Docket No. 50-368

REVIEW OF
RESISTANCE TEMPERATURE DETECTOR
TIME RESPONSE CHARACTERISTICS

SAFETY EVALUATION BY
U.S. NUCLEAR REGULATORY COMMISSION
OFFICE OF NUCLEAR REACTOR REGULATION
DIVISION OF SYSTEMS INTEGRATION
INSTRUMENTATION AND CONTROL SYSTEMS BRANCH

NOVEMBER 1980

Figure 2.1 Plot of correction factor $[f(\tau_2/\tau_1)]$ vs pole ratio $[\tau_2/\tau_1]$.

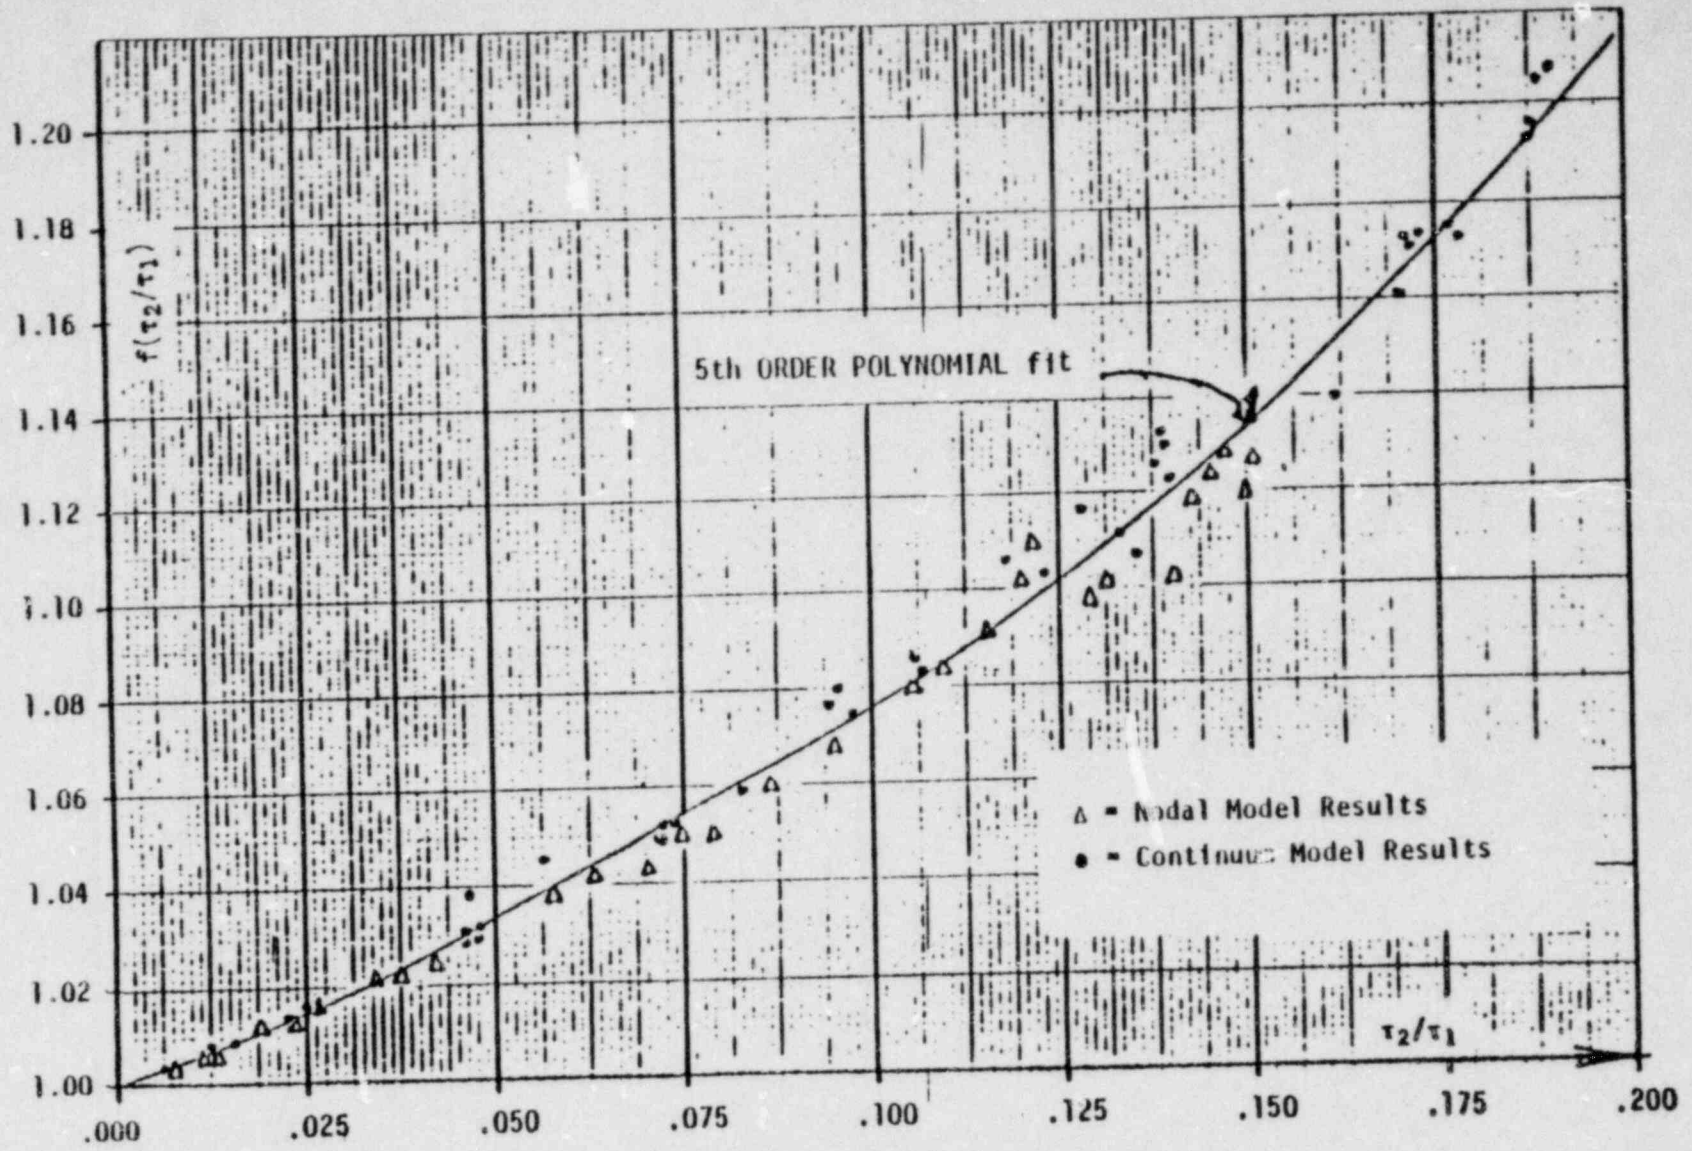
where $f(\tau_2/\tau_1)$ is given by the empirical relationship of figure 2.1. Figure 2.1 was constructed by mathematically computing the Plunge τ (equation 2.2) and $\tau_1 [1 - \ln(1 - \tau_2/\tau_1)]$ for a number of different hypothetical RTDs and plotting the ratio of the two. The hypothetical RTDs had a variety of sized and geometries, which included both hollow core and central element RTDs. Thus the curve of figure 2.1 applies to any RTD which fulfills the two requirements of section 2.2.2. The fact that this large variety of RTDs all enjoy the same $f(\tau_2/\tau_1)$ is, on the surface, rather amazing. With such a good correlation, one would naturally be inclined to search for an underlying physical reason for all RTDs to display the same $f(\tau_2/\tau_1)$. However, to date this underlying physical relationship has eluded us.

The TEC method has the advantage over the EPRI (AMS) method that it uses a recognizable line of physical reasoning to attain its result, whereas the EPRI method is emperical. The TEC method has the disadvantage that it requires a detailed knowledge of the geometry of the RTD, which is not needed for the EPRI method. However both the EPRI and the TEC method produce about equally accurate results, and thus from a regulatory point of view must be considered equally good.

Figure 3.1 Empirical Correlation Curve for Plunge τ versus LCSR τ for Rosemont RTD Model 104AFC. (Combustion Engineering RTD)

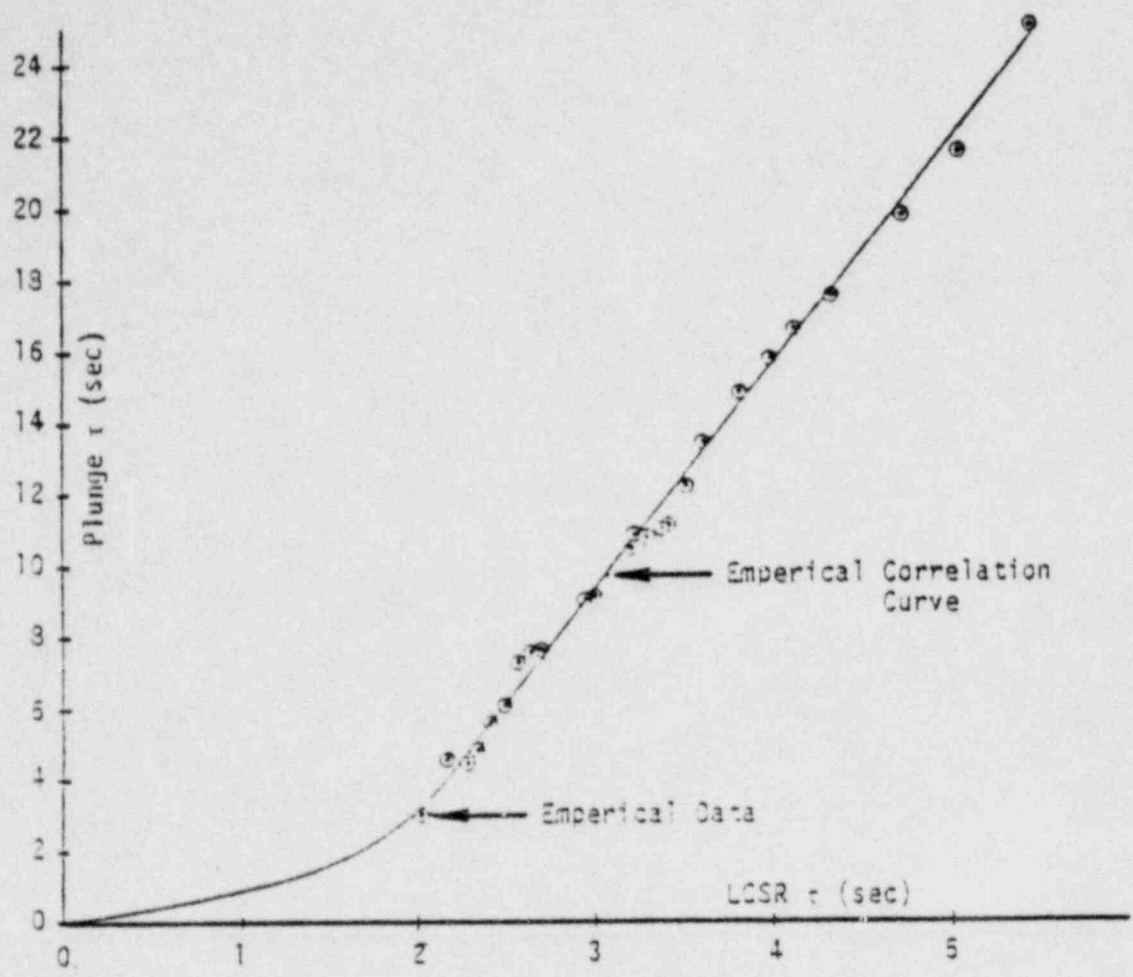
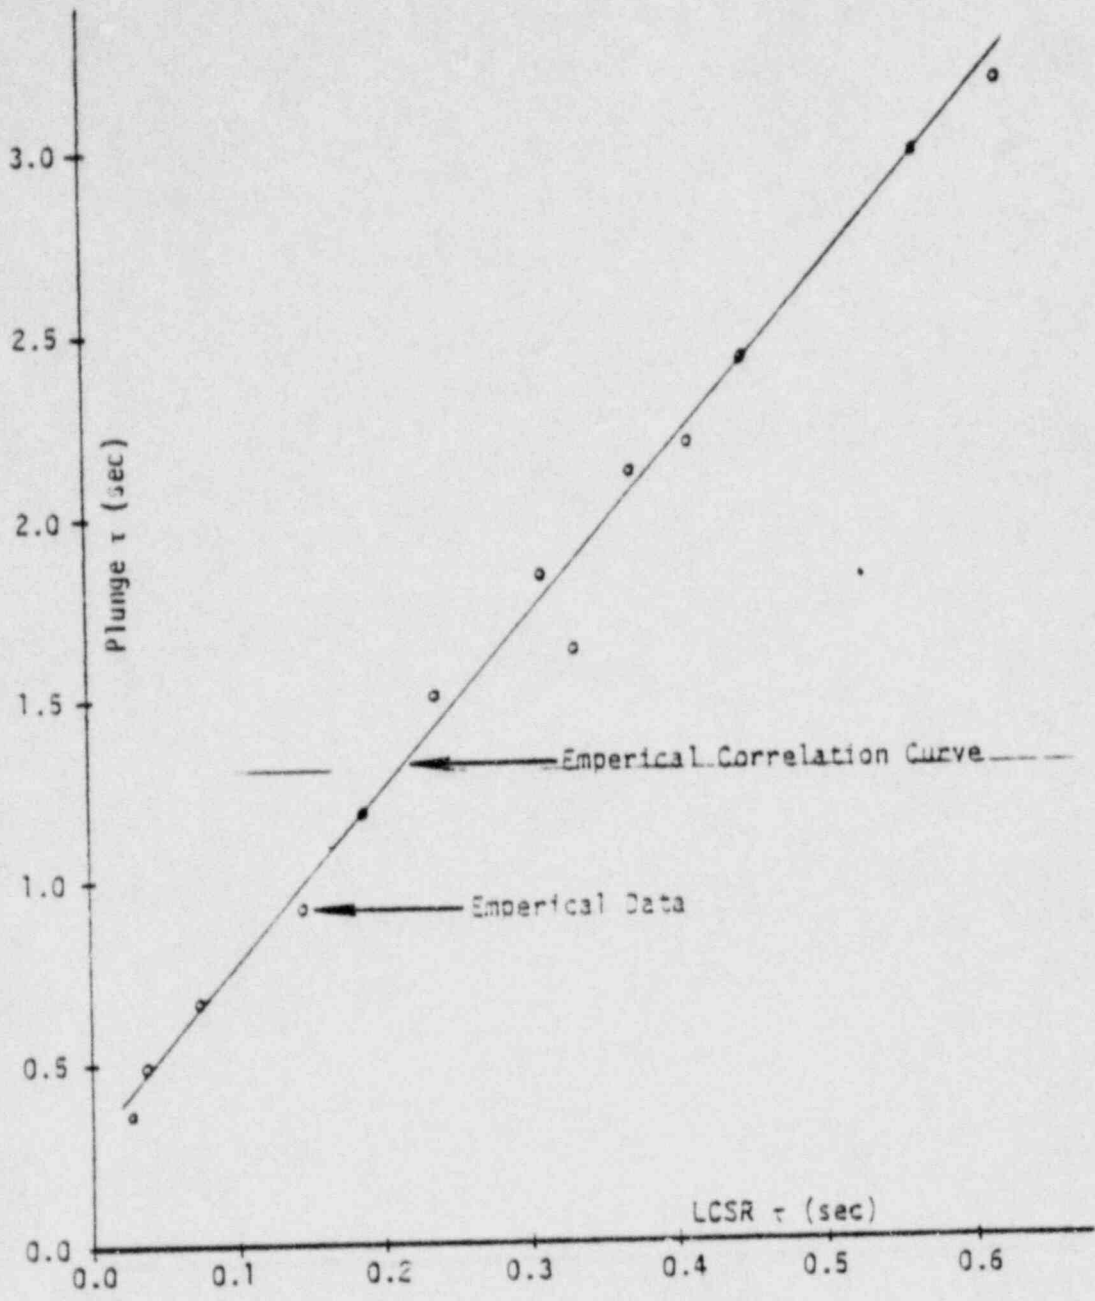
The U of T investigators attempted to correlate the Plunge τ with the LCSR τ . In making this correlation the time response of the RTD was varied by adding tape or rubber insulation around the RTD and measuring both the Plunge τ and the LCSR τ . Two such correlations are shown in figures 3.1 and 3.2.

An obvious difficulty with this method is the following: This correlation was formed by altering the thermal resistance on the surface of the RTD. When an RTD degrades, it is most likely due to increases in the thermal resistance of the RTD internals or the RTD-thermowell gap. Therefore one would expect to find a different correlation for normal degradation than that determined by adding insulation to the surface of the RTD. For this reason we do not, at present, consider the correlations of figures 3.1 and 3.2 to be sufficiently well substantiated to be used in the determination of the Plunge τ .

While not providing an accurate means of computing the Plunge τ , these correlations are useful for the degradation test. If in a degradation test the LCSR τ is found to increase, then from the correlation the approximate increase in the Plunge τ can be determined. If the Plunge τ determined in this way is near the value assumed in the safety analysis, this would indicate that it is necessary to measure the Plunge τ via the usual LCSR procedure.

Figure 3.3 Empirical Correlation Curve for Plunge τ versus SHI for Rosemont RTD Model 104AFC. (Combustion Engineering RTD)

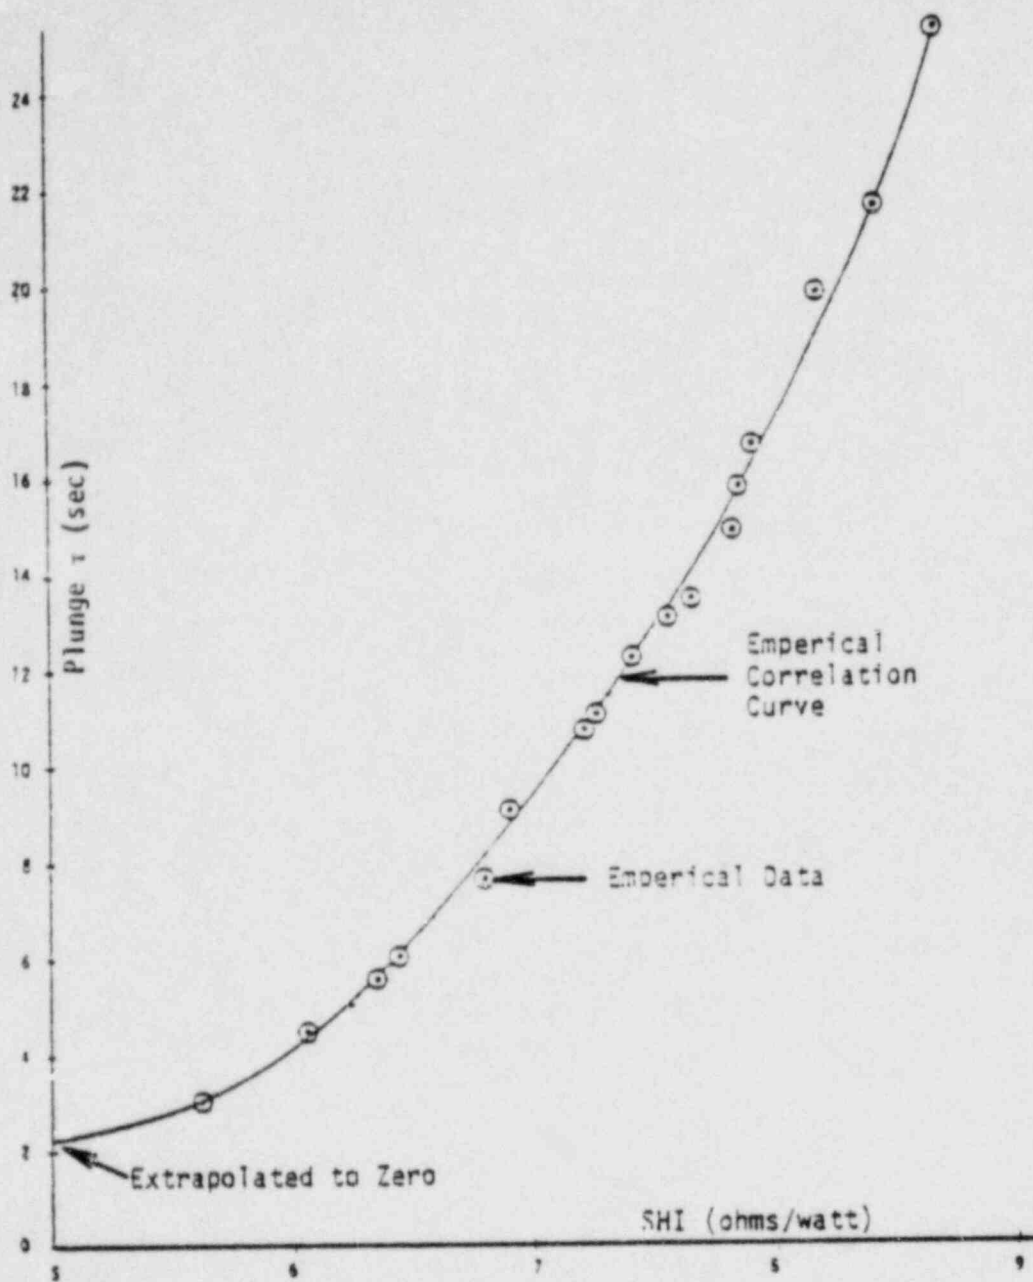
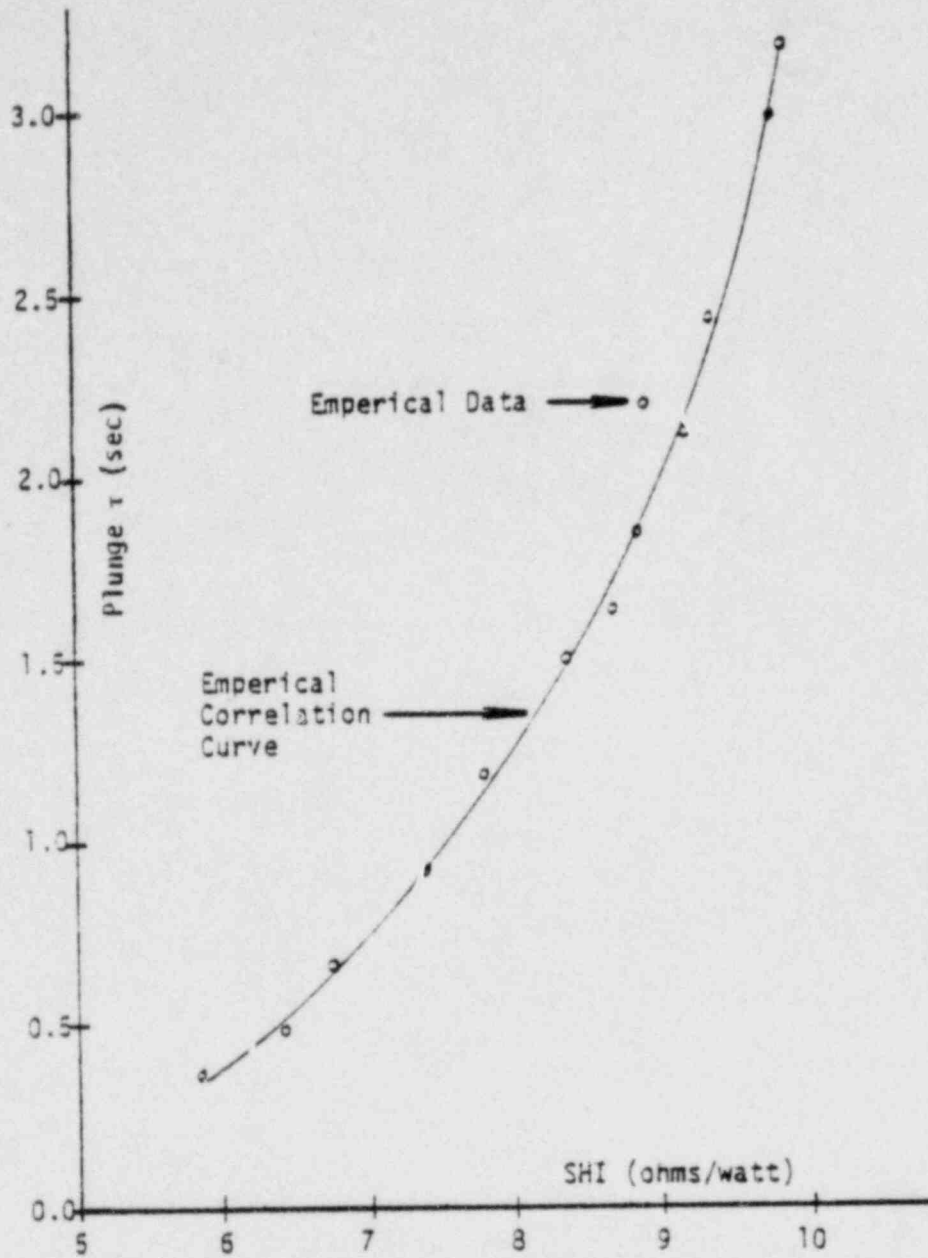
Again, as with the LCSR measurement, the RTD time response was varied by adding insulation to the surface of the RTD, and plots of Plunge τ versus SHI were constructed. Two such plots are shown in figures 3.3 and 3.4.

These correlations suffer the same problem as the Plunge τ versus the LCSR τ correlations, and thus we do not, at present, accept them as viable means for computing the Plunge τ . However, like the Plunge τ versus LCSR τ correlation, the Plunge τ versus SHI correlations would be useful in a degradation test.
